Summit Homes
Winfield Farmhouse

RE: CITY COMMENTS FOR 1617 SW BUCKTHORNE ST, LEE'S SUMMIT, MO 64082

Everstead Engineering & Design, LLC has updated the above-mentioned property construction documents per city comments as follows:

Residential Plan Review

A5.0

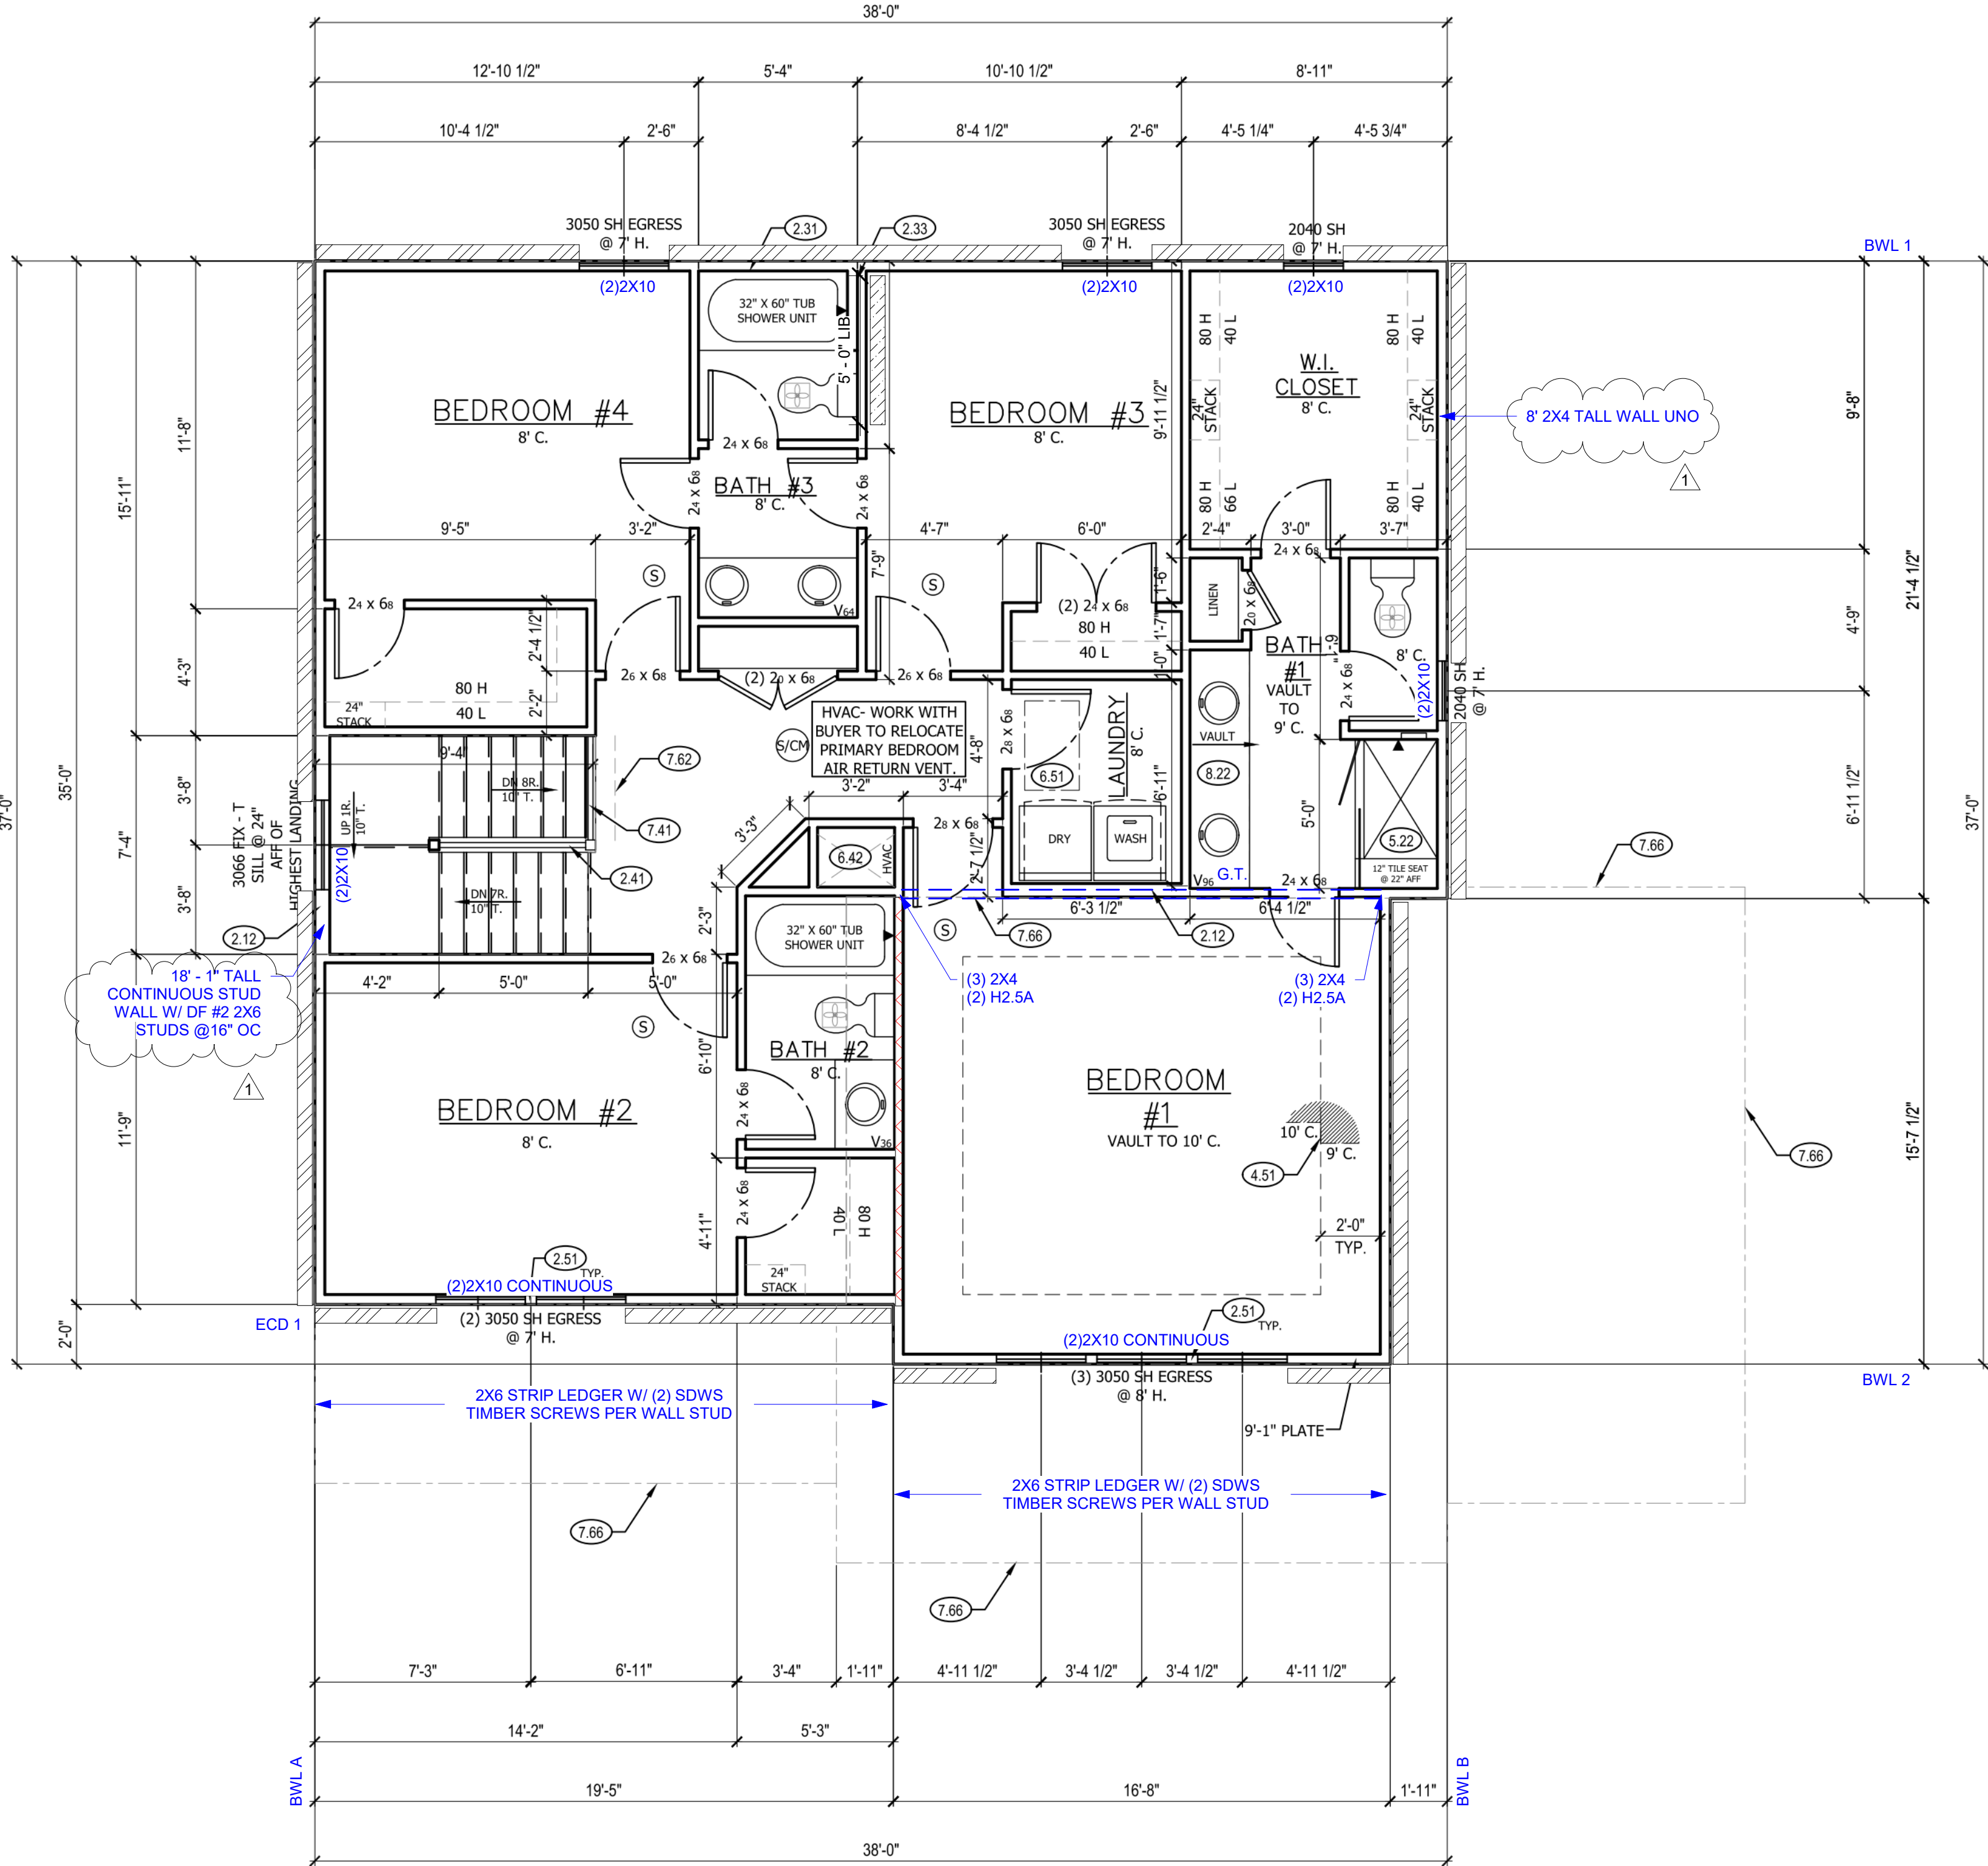
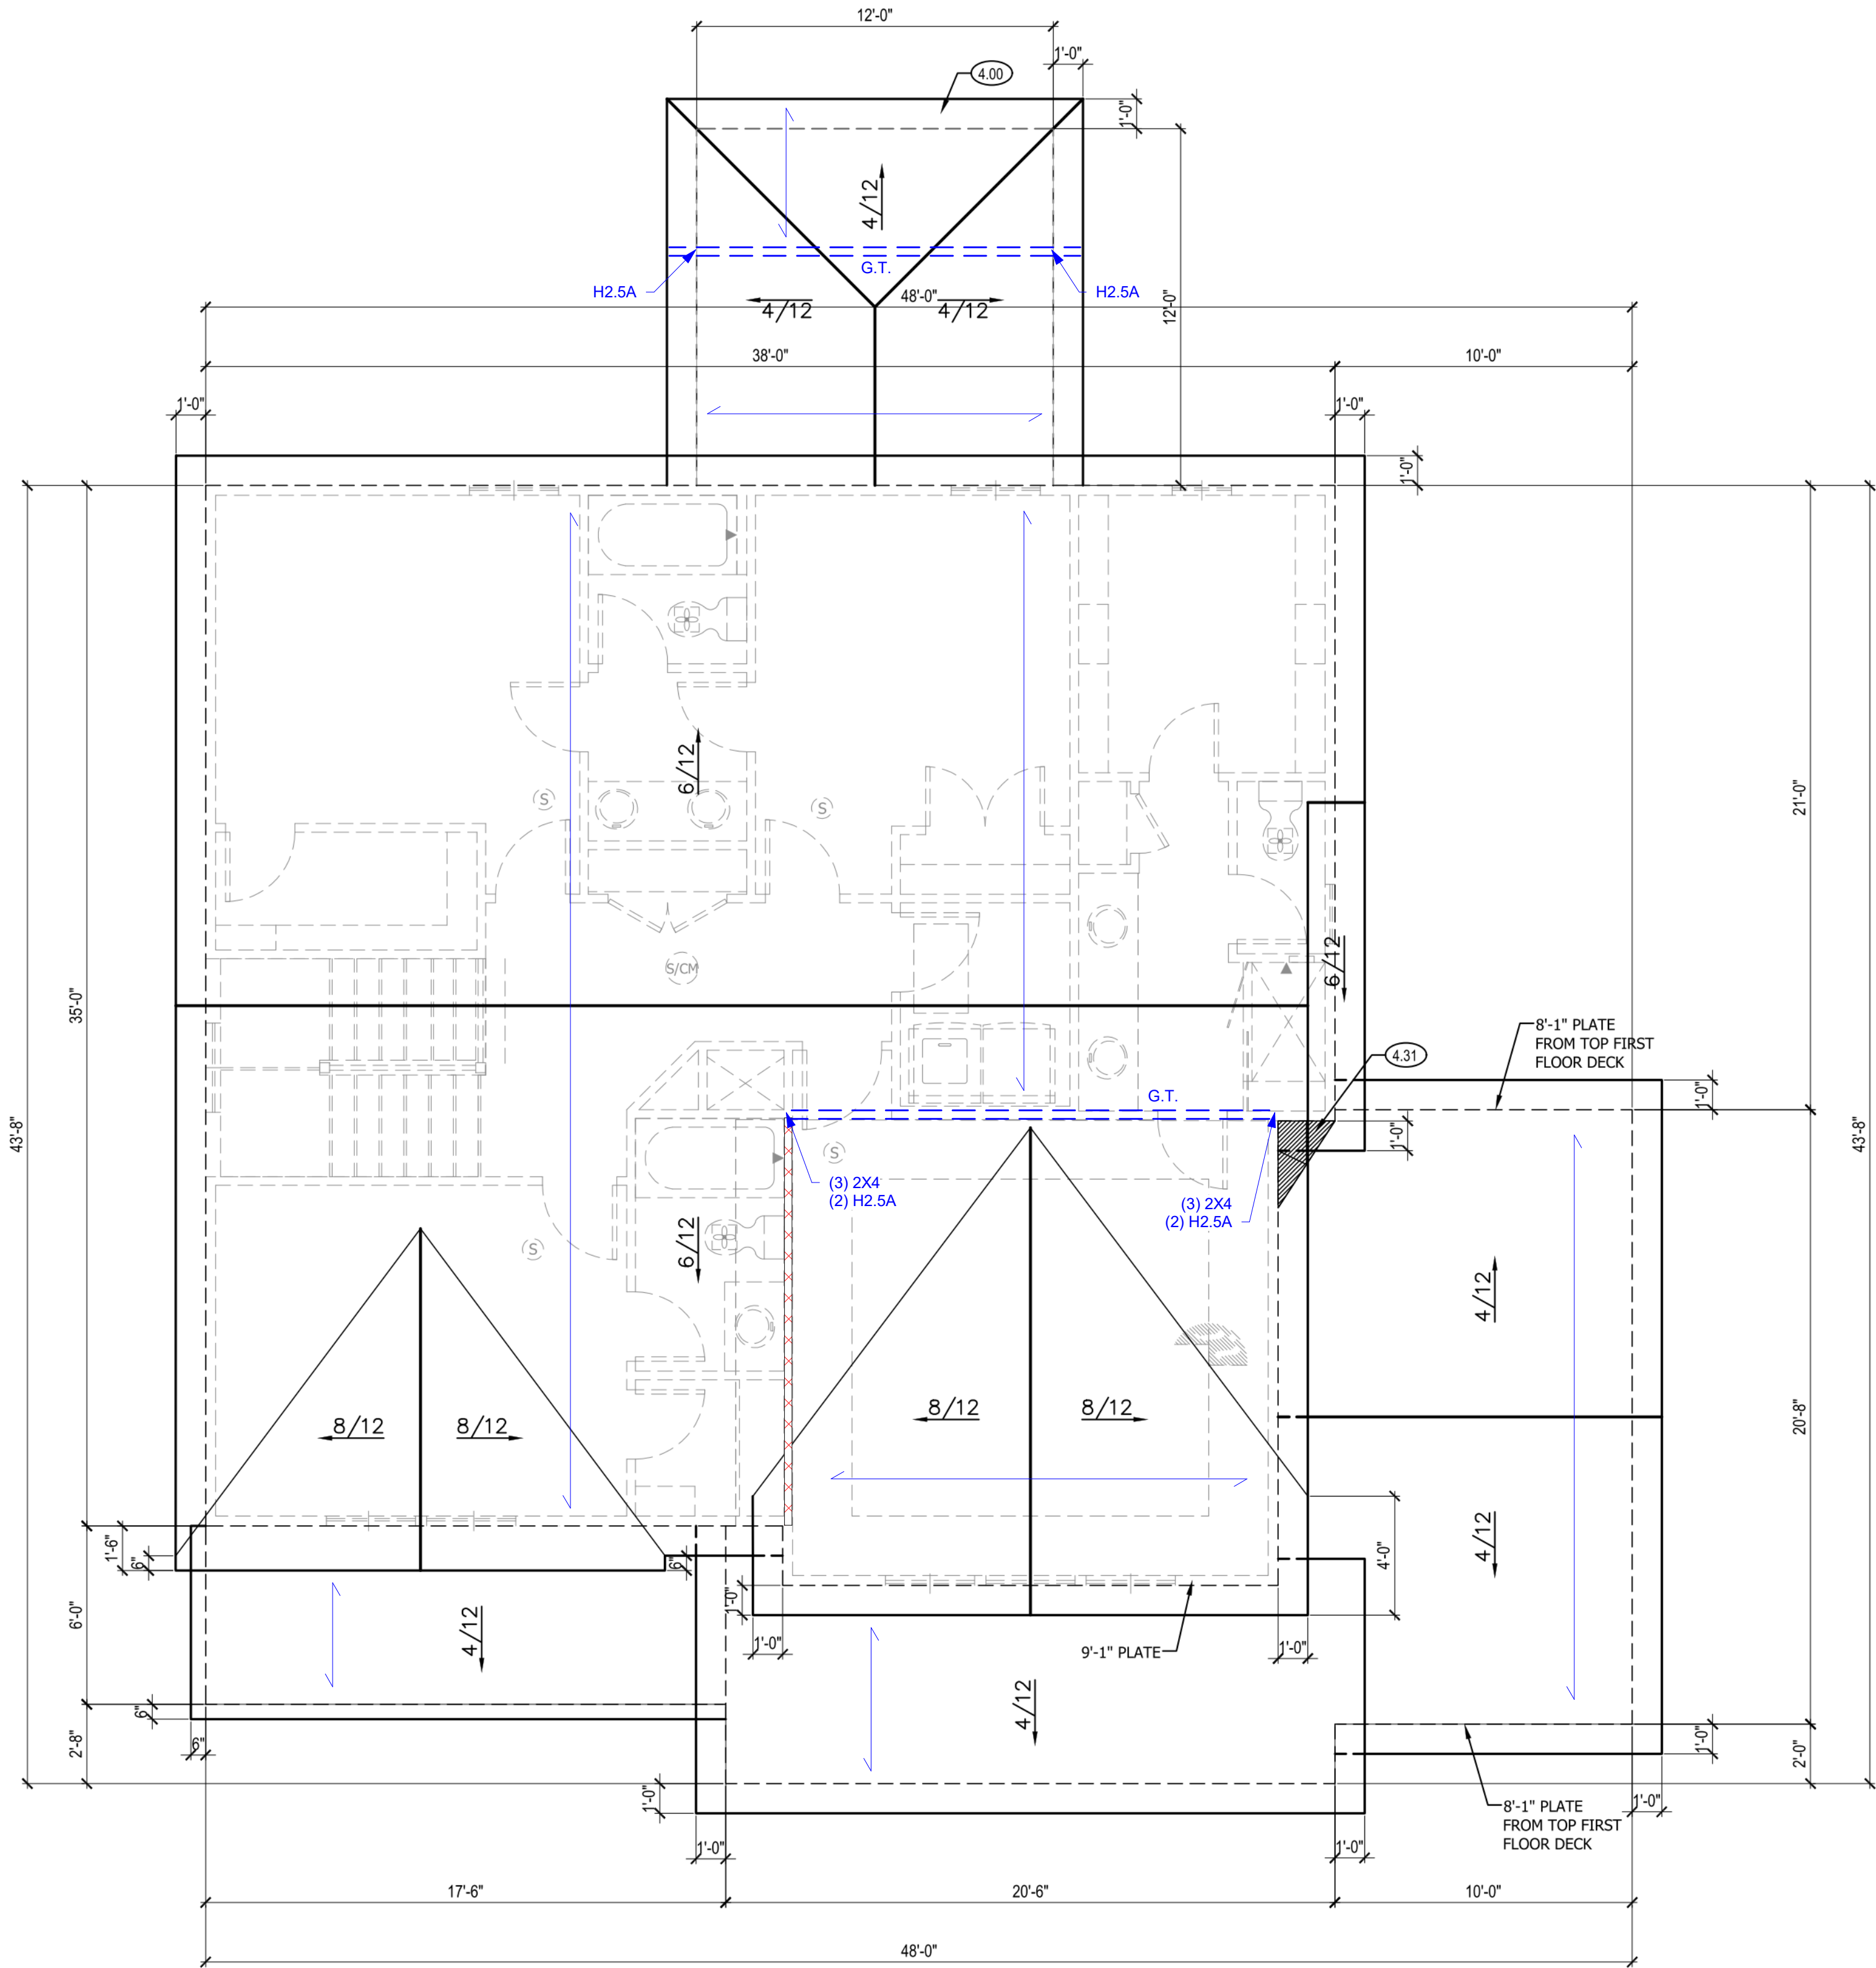
City Comment #2. "Size, height, spacing of studs. (IRC Section R602.3.1)."

Engineer's Response – All studs in bearing walls are spaced at 16" on center unless noted otherwise, see general plan notes in bottom right-hand corner of sheets A4.0 and A5.0. Wall heights and member depths are specified on plans, see sheets A4.0 and A5.0.
